CPUC Docket: A.25-05-009
Exhibit Number: TURN-7-E2
Witness: Eric Borden

**PREPARED TESTIMONY OF
ERIC BORDEN**

**ADDRESSING WILDFIRE SYSTEM HARDENING AND CUSTOMER
BATTERY PROGRAM ISSUES IN PACIFIC GAS AND ELECTRIC'S
TEST YEAR 2027 GENERAL RATE CASE**

**February 13, 2026
Errata March 26, 2026
Second Errata April 24, 2026**

Figure 1. WDRMv2 UG Miles Completed from Highest to Lowest Risk

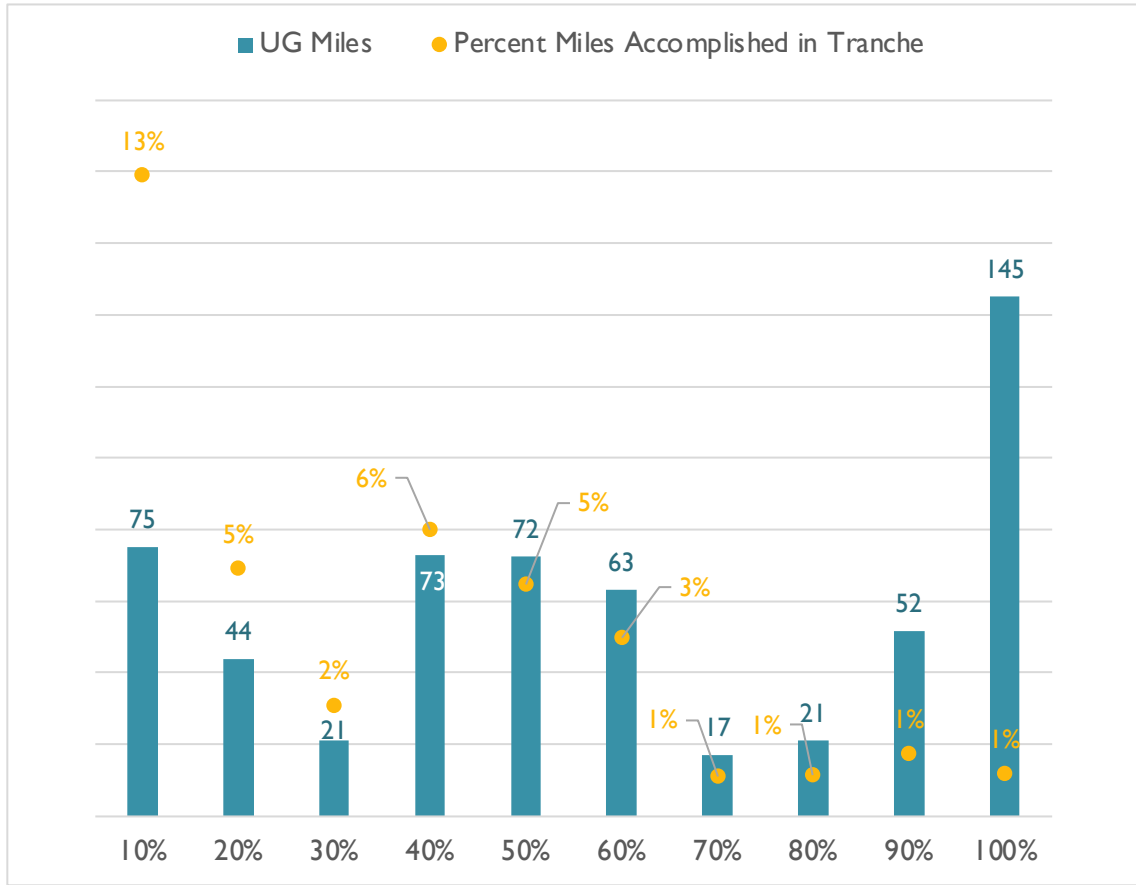
2 Of the 584 miles completed using WDRMv2 to scope projects, an astounding 64 percent were
 3 completed in the bottom 50 percent of risk; 25 percent in the bottom 10 percent! Further the
 4 figure shows that PG&E undergrounded only 13 percent of the miles (75) the in top 10 percent
 5 of risk, which consists of a total of 600 miles. In other words, a program that could be targeted to
 6 the highest risk assets could have accomplished the entire 584 miles in the top 10 percent of risk.

1 **Figure 3. WDRMv3 UG Miles Completed from Highest to Lowest Risk**

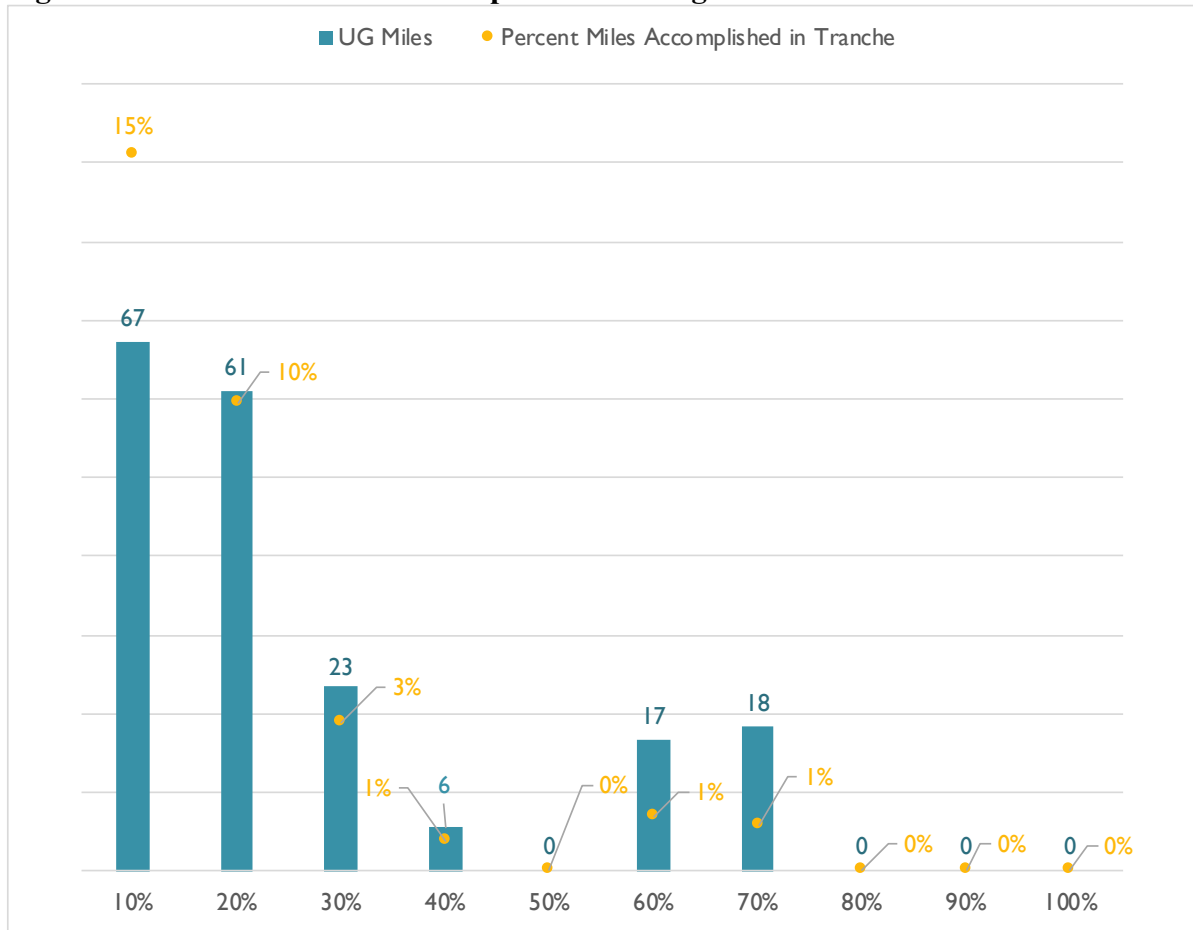
7 Slightly improved results can be seen below for the 192 underground miles that have utilized
 8 WDRMv3. Here again, however, a purely risk-based program could have deployed all 192 miles
 9 within the top 10 percent of risk (which has 435 miles in total), rather than just 35 percent.

1 **Figure 4. WDRMv3 UG Miles Completed from Highest to Lowest PG&E Risk Tranche**

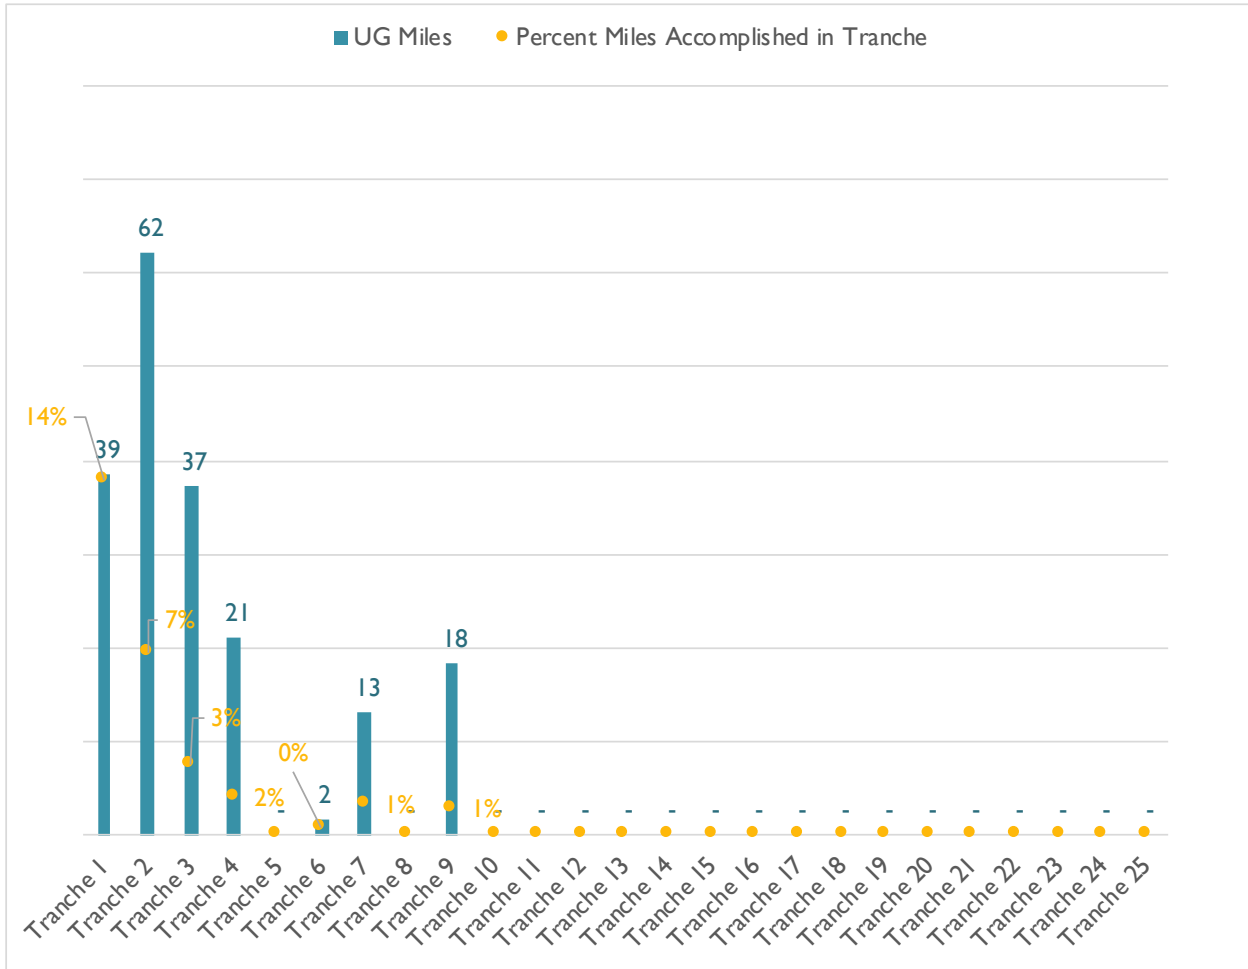
6 I expect that PG&E will counter this analysis with its own definition of risk. Rather than defining
7 percentiles of risk according to risk scores, PG&E defines “risk” by a “count” of circuit
8 segments when ranked from highest to lowest risk.¹⁴ For example, if there are 1,000 circuit
9 segments ranked from highest to lowest risk, the top 200 are the “top 20 percent” of risk,
10 regardless of what the distribution of risk scores is among these circuits. In an extreme scenario

1 **Figure 5. Undergrounding Miles by Risk Model Version (2023-2026)**

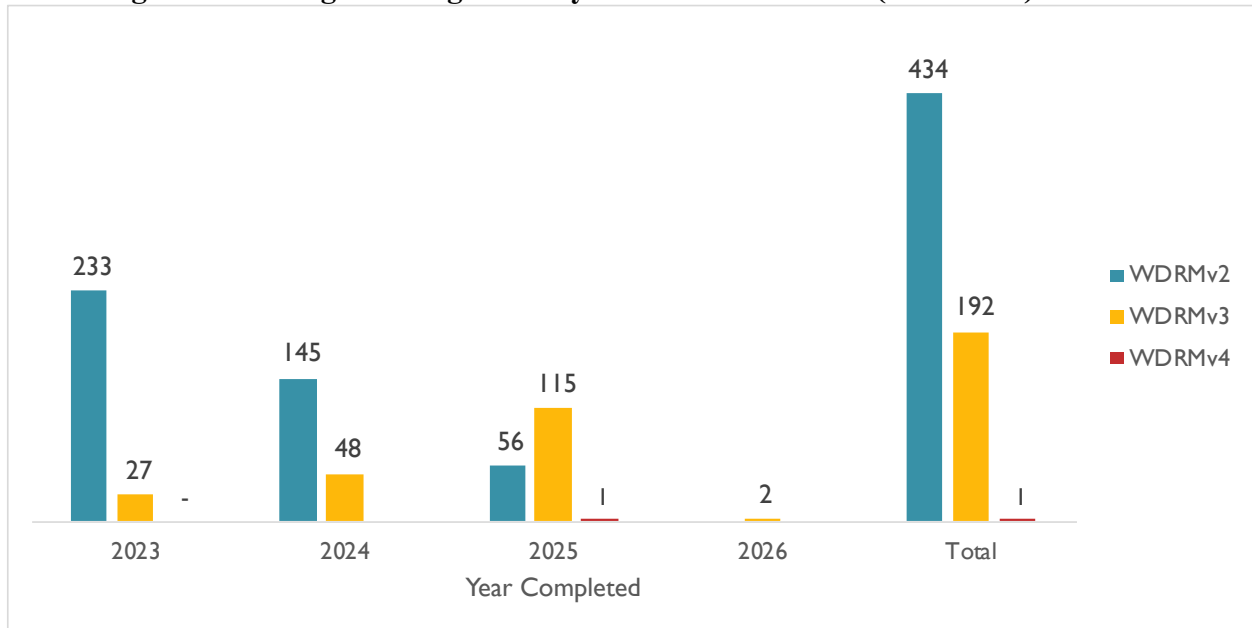
15 Another striking aspect of PG&E's undergrounding performance is the degree to which projects
16 coming online in recent years rely on outdated risk modeling. This means that PG&E is unable to
17 rely on its latest assessments of risk for virtually any of the projects that it has undergrounded. Of
18 the 627 miles completed from 2023 to 2026, over two-thirds (69 percent) utilized just the second
19 version of PG&E's risk model, due to the fact that undergrounding scoping, site preparation, and
20 other issues take so long.⁴²

6 So while continual improvement in PG&E’s risk modeling approach has been a key focus of the
7 CPUC and OEIS, it has hardly yielded better project selection in terms of targeting what PG&E
8 believes are the highest risk locations for undergrounding projects. Indeed, for the 2027 forecast
9 in this GRC, 180 of the 307 miles would use previous risk models (v2 and v3),⁴³ despite the fact
10 that the Commission is ostensibly deciding on expenditures for 2027.
